TECHNICAL BULLETIN INDEX
Sorted by Bulletin Number
04/03/86

DATE: November 3, 1980
 REVISION DATE: January 17, 1983
 BULLETIN NO.: CC:1
 PRODUCT: 26-3001/2 Color Computer
 SUBASSEMBLY: N/A

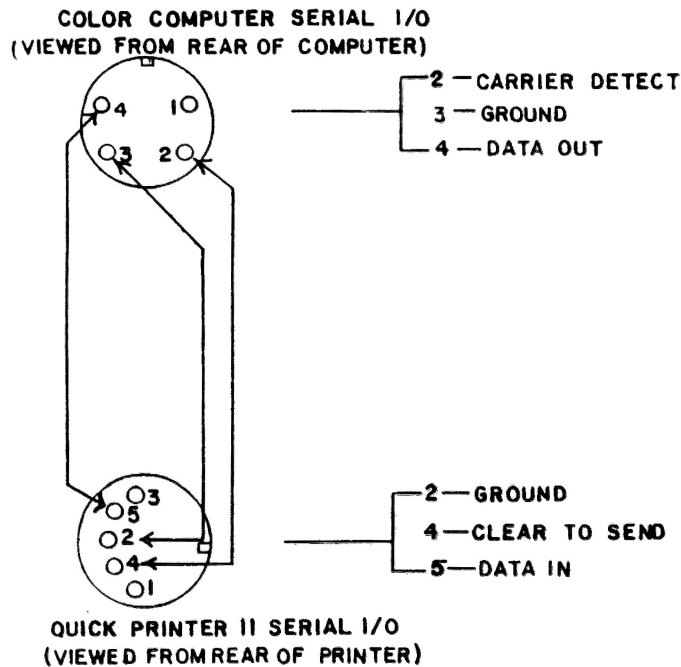
PURPOSE: When connecting a Quick Printer II to the Color Computer, printer only prints one letter and then stops.

The Color Computer Preliminary Documentation concerning RS232 interfacing shows the incorrect pinouts of the RS232 port.

Use the following diagram to interconnect the Color Computer and Quick Printer II.

FIGURE 1

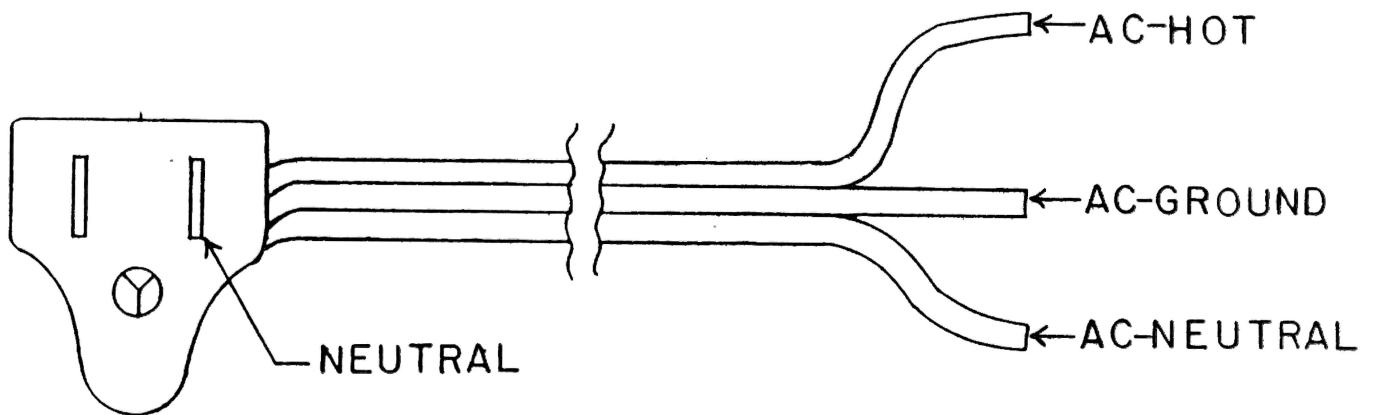
Following repairs to ALL units, be certain to properly re-connect the AC line cord to the power supply according to the following charts and diagram.

<u>AC LINE CORD</u> WIRE	<-connects to->		<u>PCB TERMINAL DESIGNATION</u>		Videotex
	'Old' style	PCB	'Revised' PCB		
AC GROUND (see Figure 1)		E5	E8		E5
AC NEUTRAL (see Figure 1)		E6	E6		E6
AC HOT (see Figure 1)		E7	E7		E7

Verify that the AC line cord terminals are properly identified by doing a continuity check using an ohmmeter.

FIGURE 1

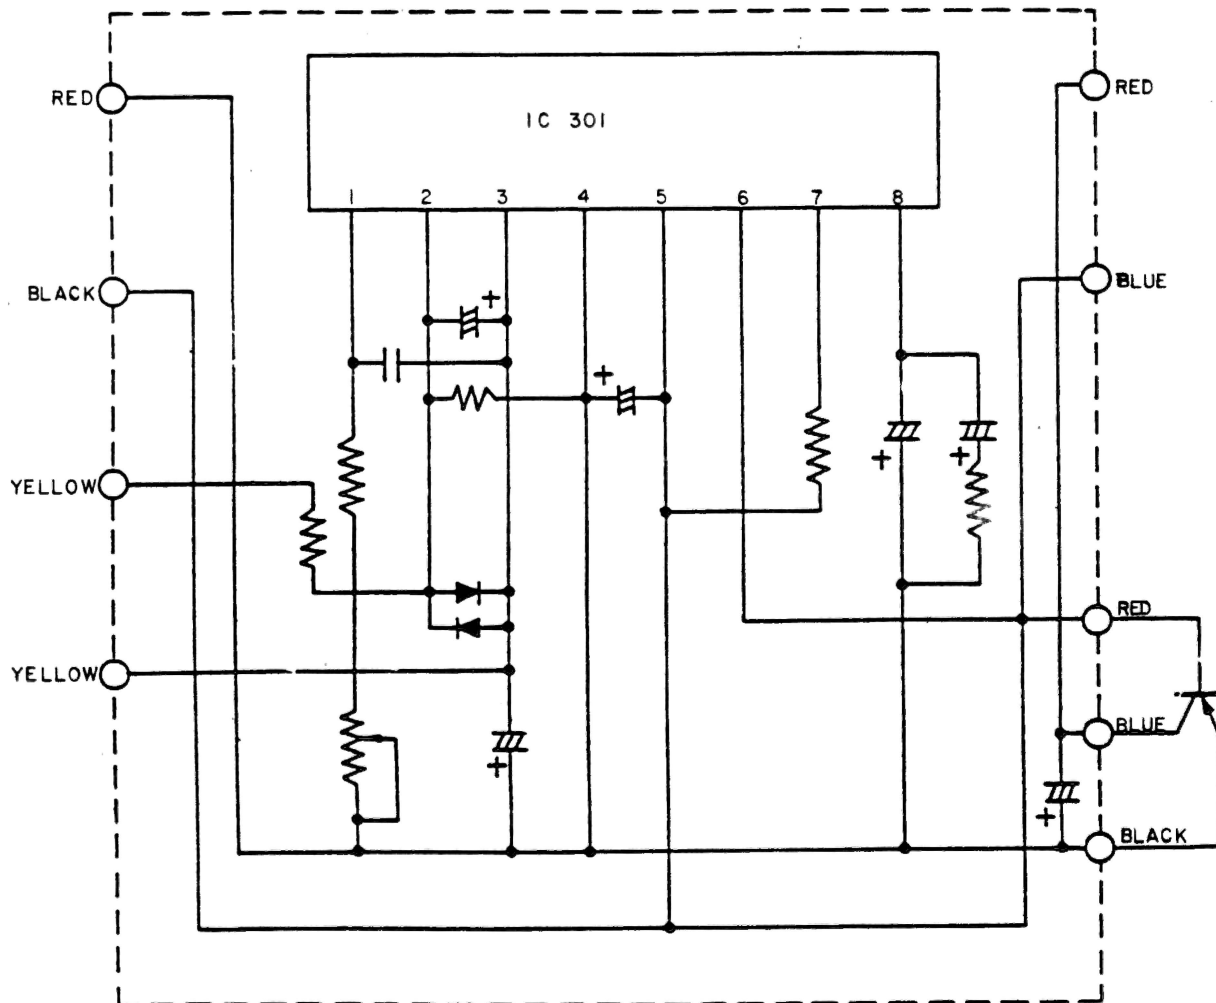
Figure 1 is the schematic for the **ORIGINAL** (unmodified) PCB. CN-3 is the large multi-wire connector on the main PCB. Note that the RED wire from the Motor Control PCB goes to pin B7 of CN-3, and that the BLACK wire goes to pin A7 of CN-3. Note that there is no WHITE wire connected to this board.

- (1) ORIGINAL board being replaced with PHASE 1 board -- Remove BLACK wire from pin A7 of CN-3 and insert it into pin B14 of CN-3. Plug WHITE wire from PHASE 1 board into pin A7 of CN-3.

- (2) ORIGINAL board being replaced with PHASE 2 board -- Remove BLACK wire from pin A7 of CN-3 and insert it into pin B14 of CN-3. Plug WHITE wire from PHASE 1 board into pin A7 of CN-3.
- (3) PHASE 1 board being replaced with ORIGINAL board -- No wiring changes are necessary, but **DO NOT** remove the satellite PCB unless it is **PROVEN** defective. The unit must remain as a PHASE 1 configuration.
- (4) PHASE 2 board being replaced with ORIGINAL board -- **DON'T!!** Replace the PHASE 2 board **ONLY** with the PHASE 1 assembly, or another PHASE 2 PCB.
- (5) PHASE 1 (or 2) board being replaced with a PHASE 2 (or 1) board -- No wiring changes are necessary.

FIGURE 2

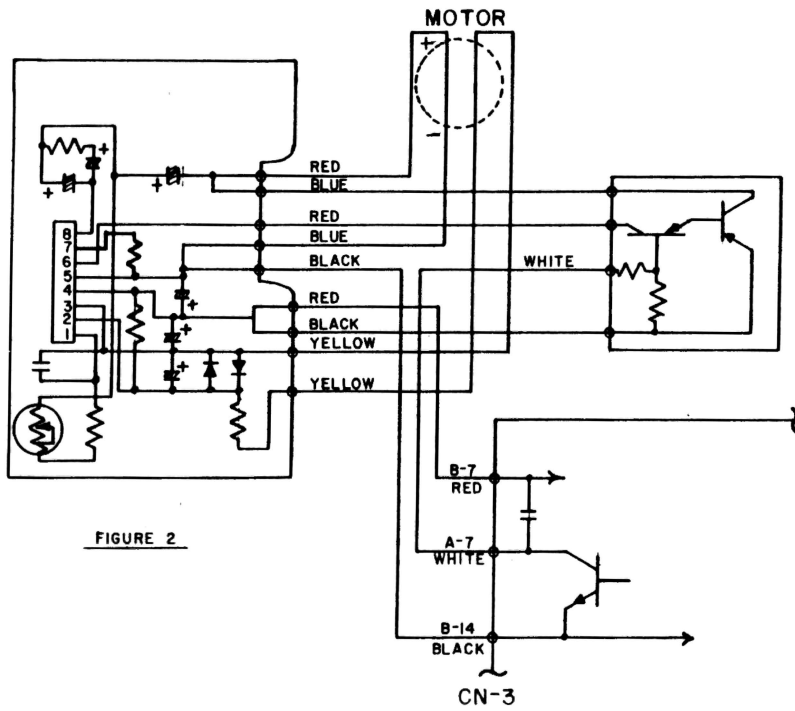
Figure 2 is the wiring diagram for the Motor Control/Satellite PCBs as used in Phase 1. Note that the RED wire is connected to pin B7 of CN-3, the WHITE wire is connected to pin A7 of CN-3, and the BLACK wire is connected to pin B14 of CN-3.

FIGURE 3

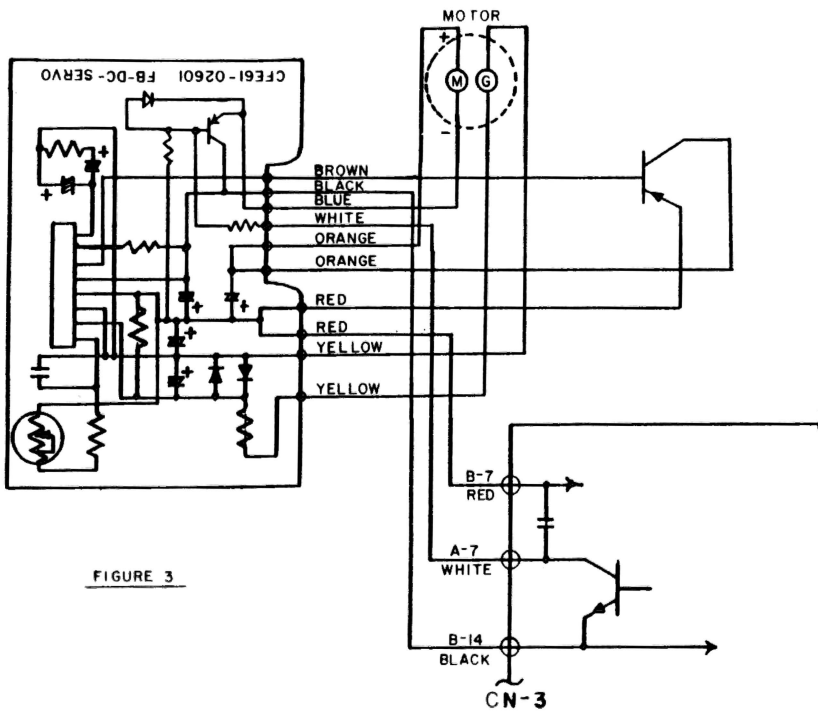
Figure 3 is the new Motor Control PCB as used in Phase 2. Note that the RED wire is connected to pin B7 of CN-3, the WHITE wire is connected to pin A7 of CN-3, and the BLACK wire is connected to pin B14 of CN-3.

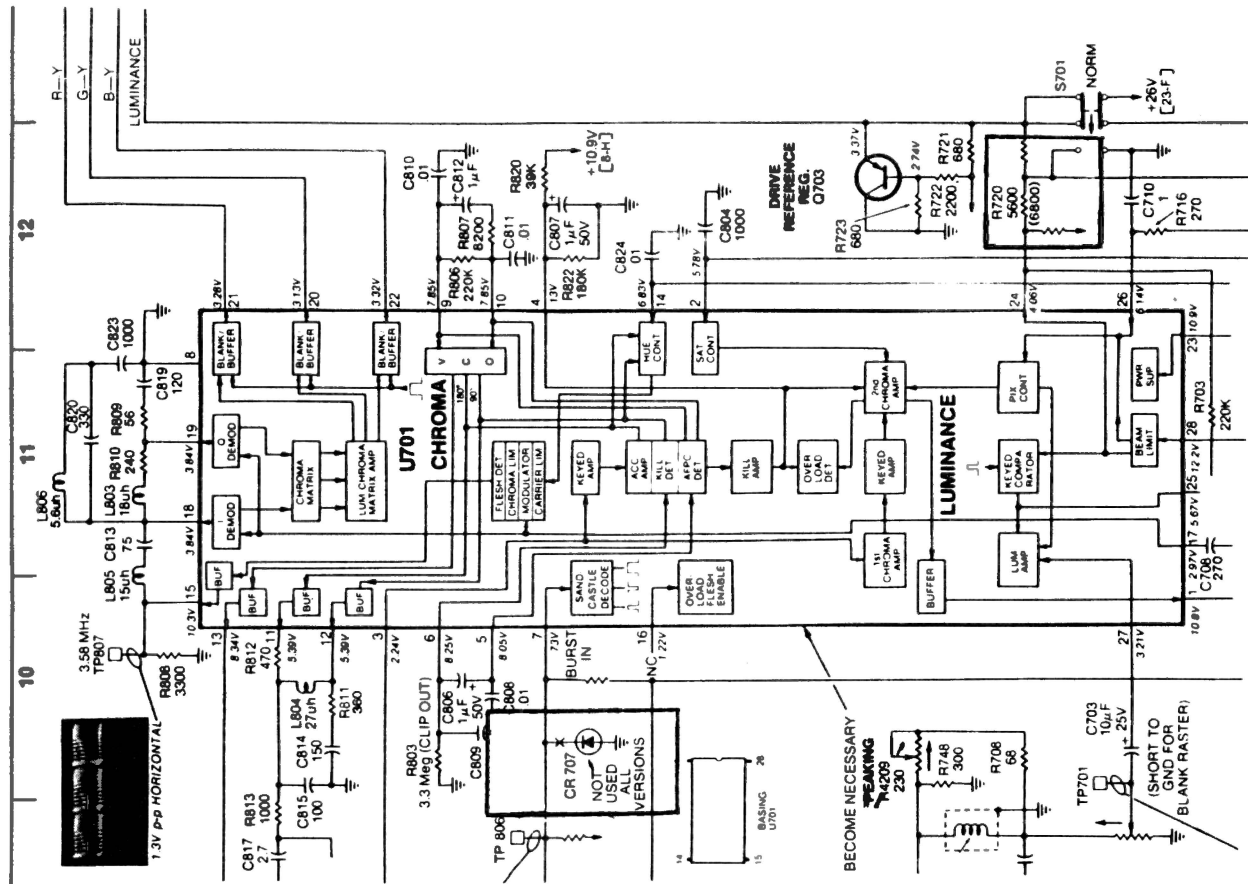
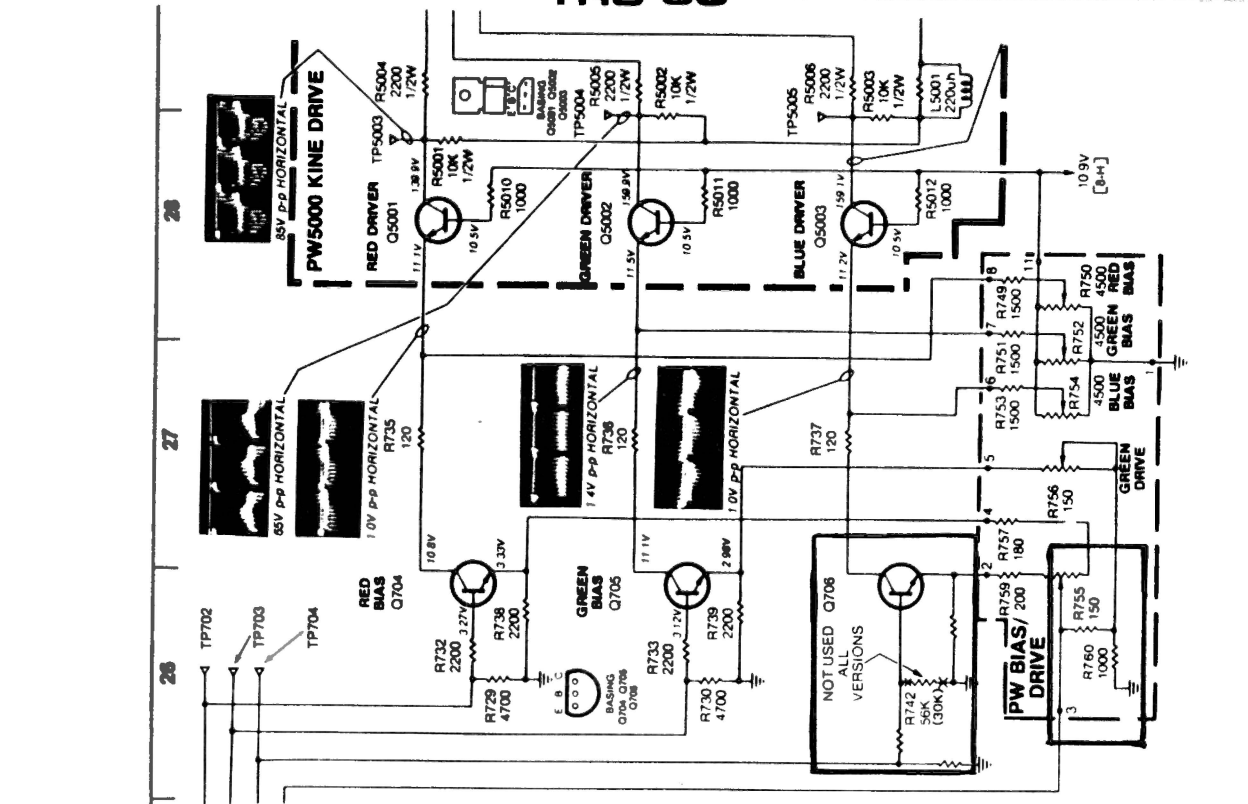
The following chart shows the necessary parts to be added, deleted, or changed when installing any given revision of U701. The correct parts that should be in the circuit are included with the IC. Parts listed as "OMIT" should not be installed in the circuit, and should be removed if they are already installed.

For your information, the following page highlights the schematic areas effected by this modification.

U701 Rev.	CR707 (R720 on main PCB	R742)	R755 (on bias/drive PCB)	R760
-1	OMIT	5.6K	OMIT	150	OMIT
-2	OMIT	5.6K	OMIT	150	1K
-3	*****THIS REVISION OF U701 IS NOT USED*****				
-4	OMIT	5.6K	OMIT	150	OMIT
-5	OMIT	5.6K	OMIT	OMIT	OMIT
-6	031 (SEE TEXT)	5.6K	56K	150	OMIT
-7	OMIT	5.6K	OMIT	150	OMIT
-8	OMIT	6.8K	30K	150	OMIT
-9	OMIT	6.8K	30K	OMIT	OMIT
-10	OMIT	5.6K	OMIT	150	OMIT

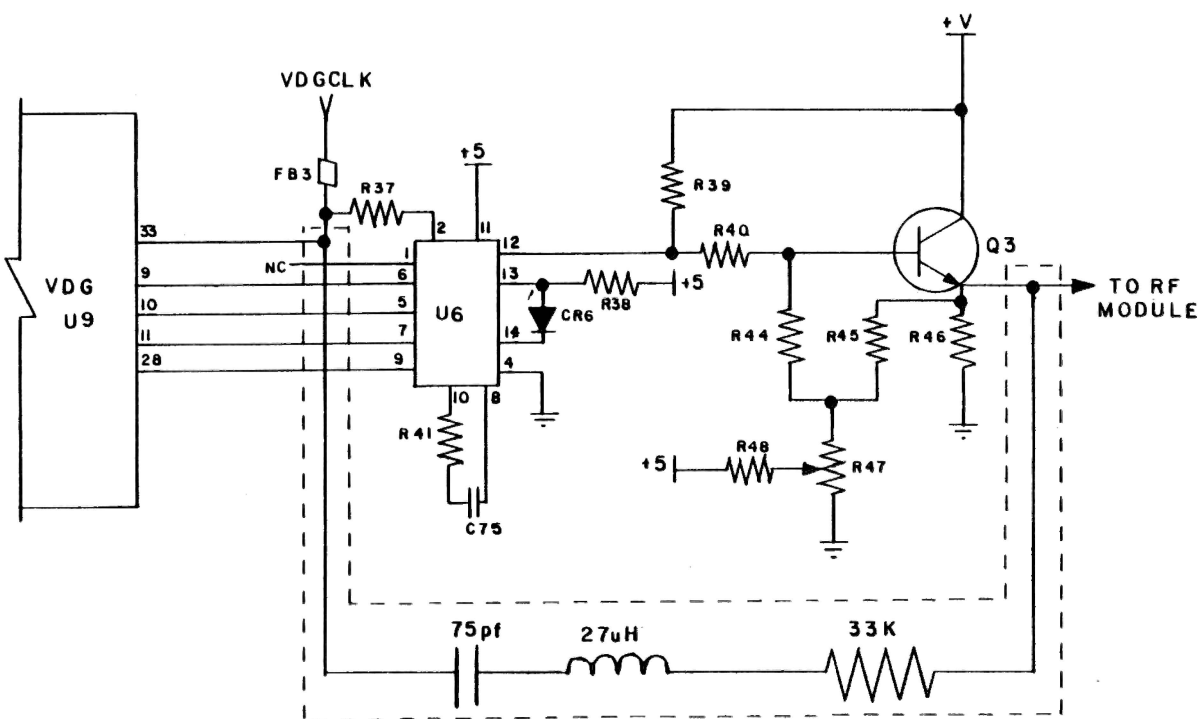
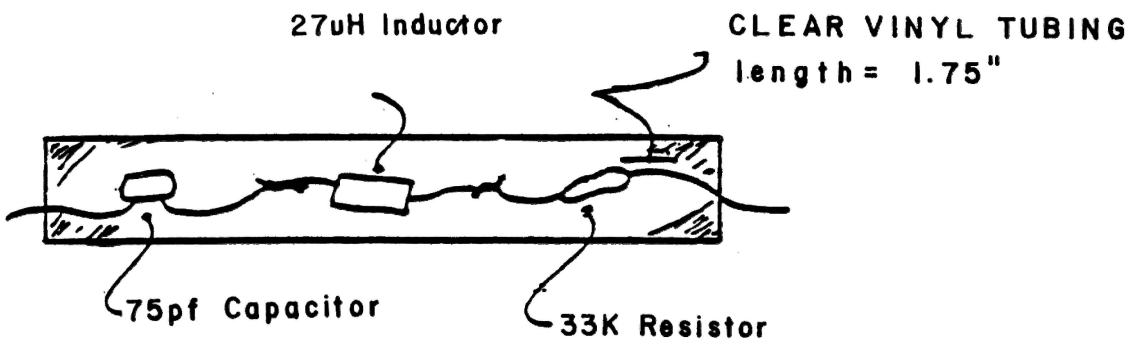
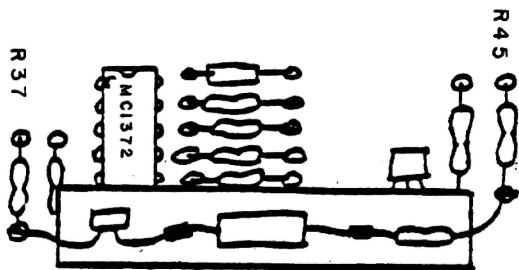
Modification 2 is the addition of a 33K 1/4 watt 5% resistor (National Parts number N-0324EGE), a 75pf capacitor (National Parts number CC750JJWP), and a 27µH inductor (National Parts Number ACA-8165) all connected in series between the emitter of Q3 and U9 pin 33 (MC6847). The enclosed drawing details this modification.

FIGURE 1
 LOCATION OF CAPACITORS TO BE CUT
 ('D' AND 'E' BOARDS IDENTICAL)

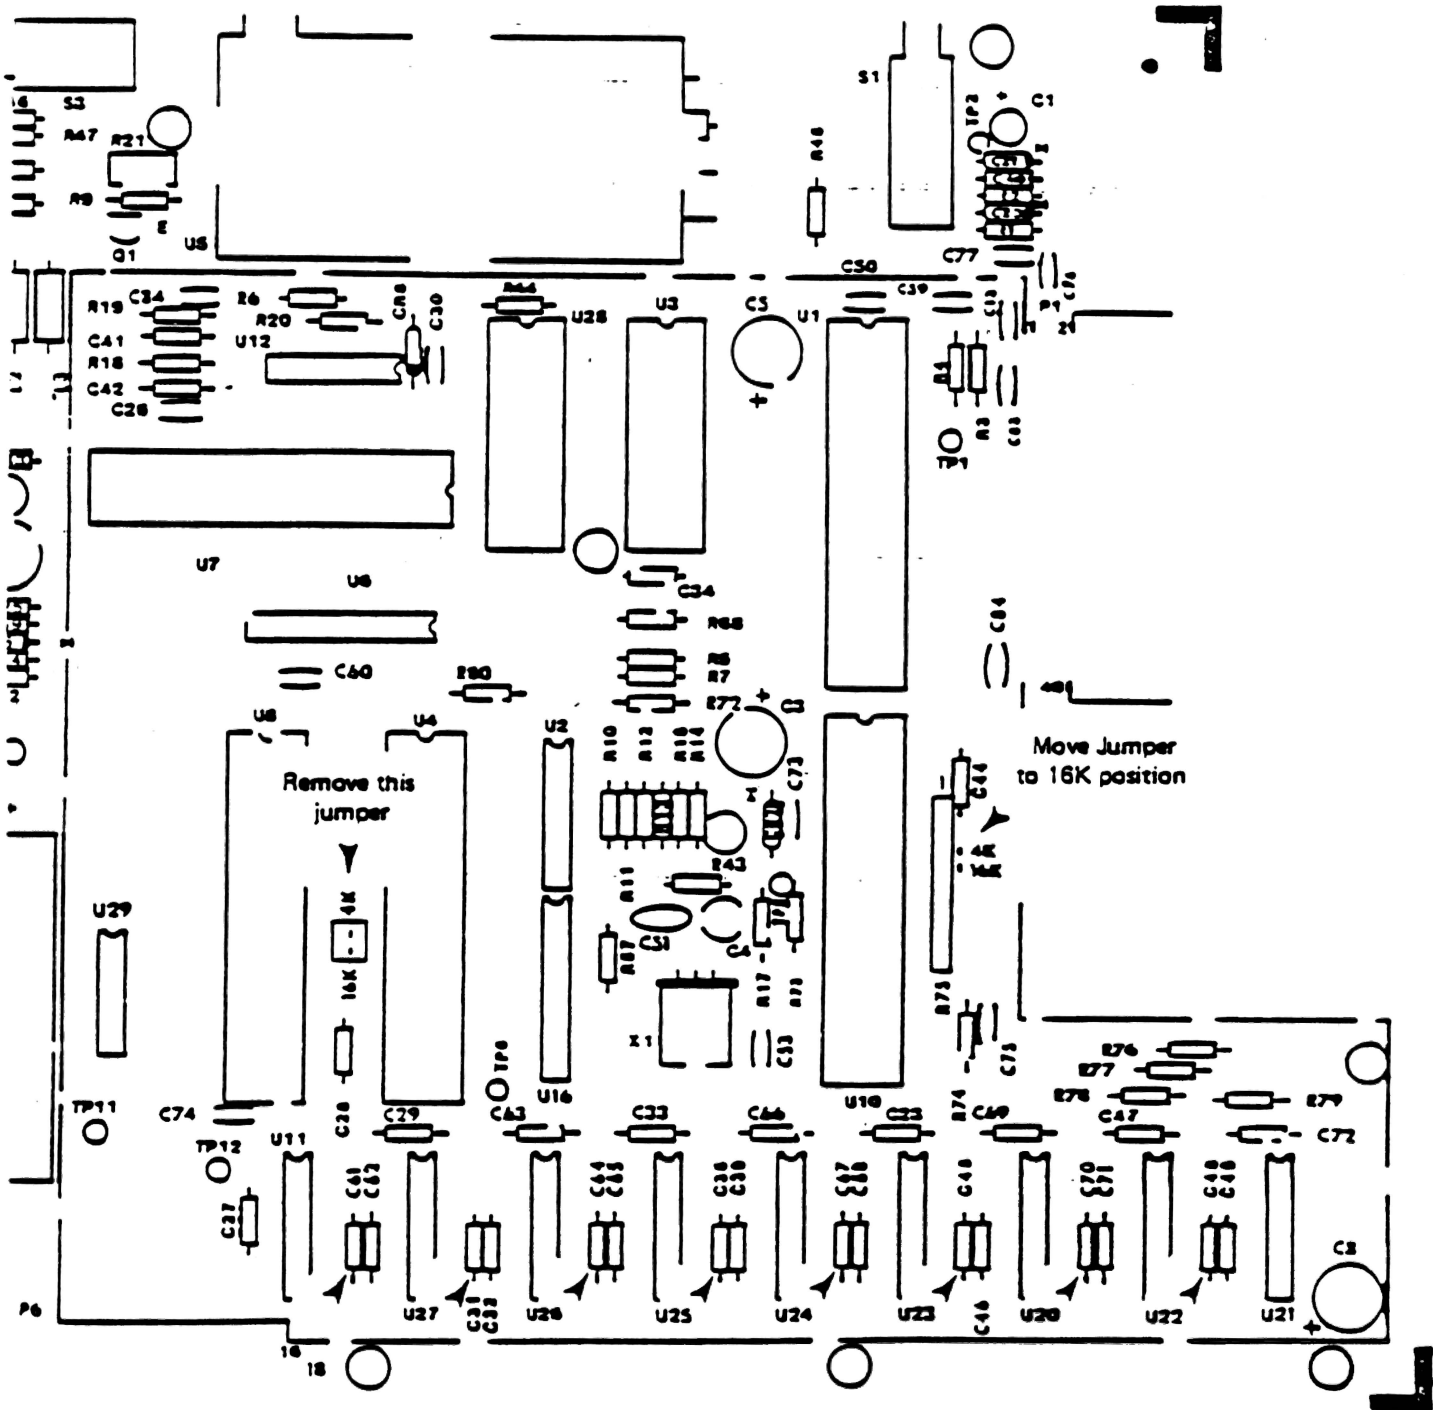
- 9) Remove capacitors C61, C31, C64, C35, C67, C45, C70, C48. Refer to Figure 1 for their locations.
- 10) Locate the two tall staking pins at the R83 position to the right of U10. Install the ferrite bead over the pin closest to R75, and install the SMALLER of the two jumper plugs onto BOTH staking pins.

DELETE CAPACITORS : C81, C31, C64, C35, C67, C45, C70, and C48.

FIGURE 2
REVISION 'D' FOIL SIDE CUTS

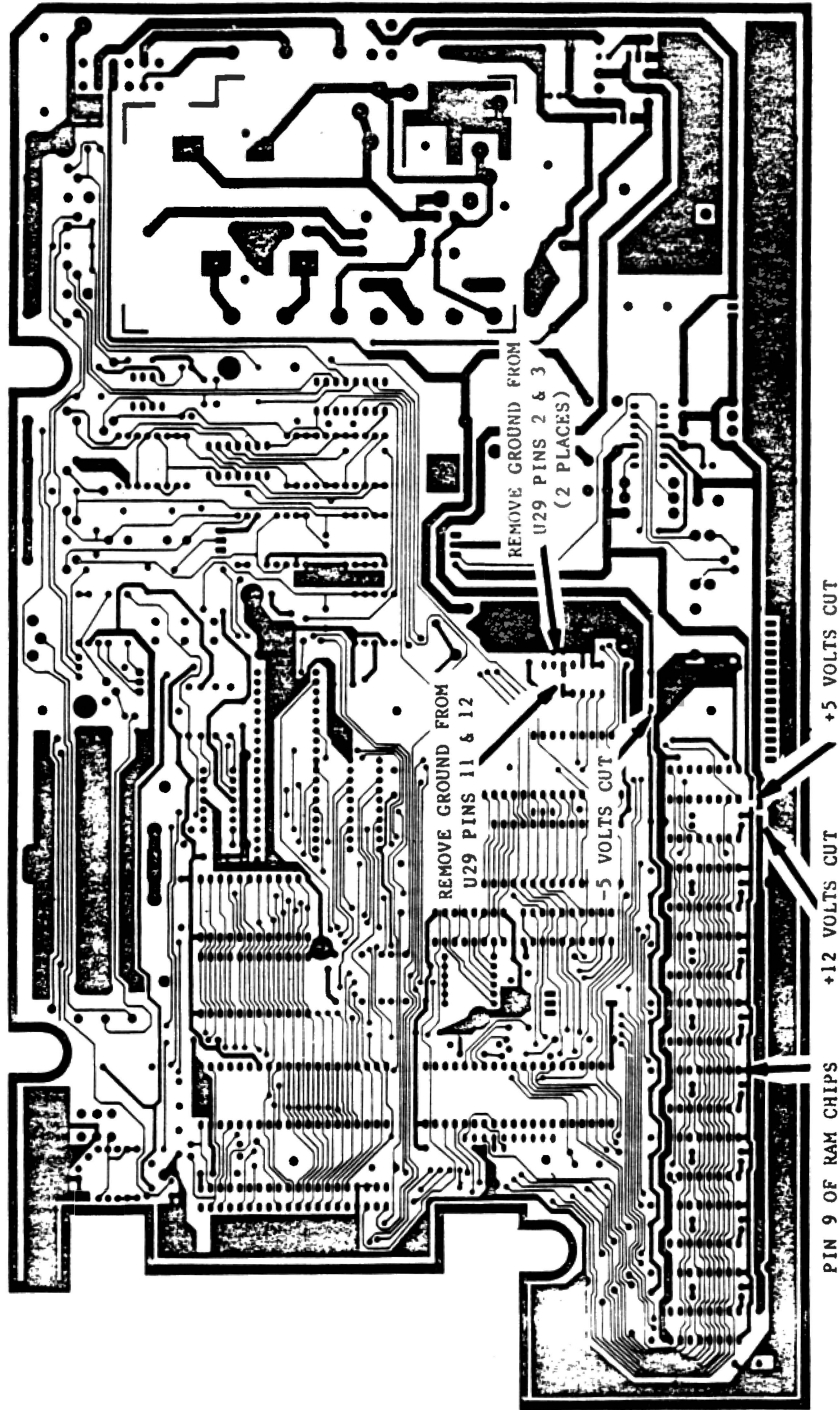
The old style Revision 'D' PCB can be modified to accept the 64K upgrade kit. The following is the procedure to modify the old style Revision 'D' board.
